19th December 2024

**Statement of Environmental Effects
Modification of Development Consent DA2023/1869
Demolition works and construction of a residential flat building
54 – 58 Beaconsfield Street, Newport**

Figure 1 - Plan extract showing 8.5 metre building height standard breaching elements.

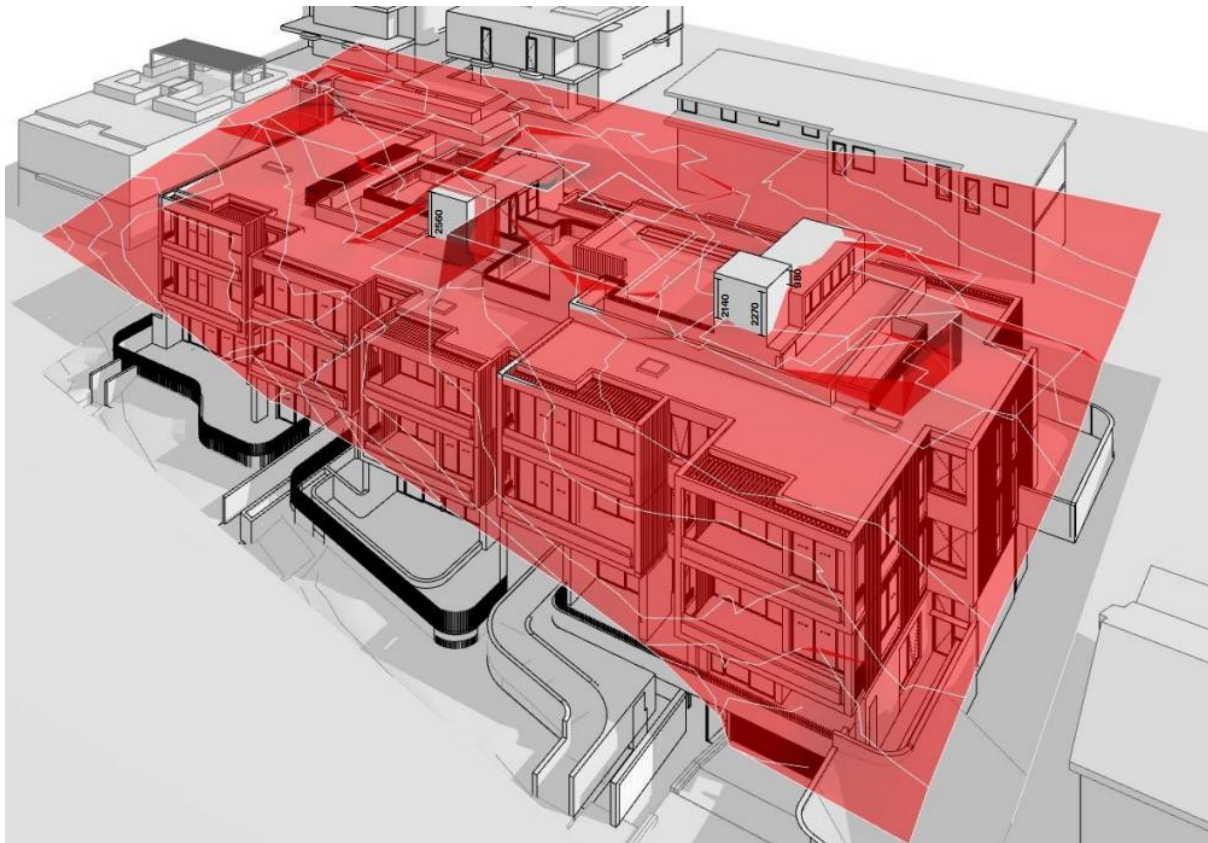
It has been determined that the finished roof level of the development has been increased by 450mm and the lift overruns by between 250 mm and 730mm. Whilst the majority of the development continues to sit comfortably below the height standard the following building height blanket diagram demonstrates that a number of roof elements including portion of the lift overruns and the eastern lift/circulation stair enclosure breach the standard by varying extent.

These plans demonstrate that the western lift overrun breaches the height standard by between 620mm and 1.315 metres (15.4%) whilst the eastern lift overrun breaches the height standard by between 2.56 metres (30.1%), the eastern lift overrun by between 980mm (11.5%) and 2.27 metres (26.7%) with the eastern lift/stair enclosure and portions of the roof form breaching the standard by a maximum of 300mm or 3.5%.
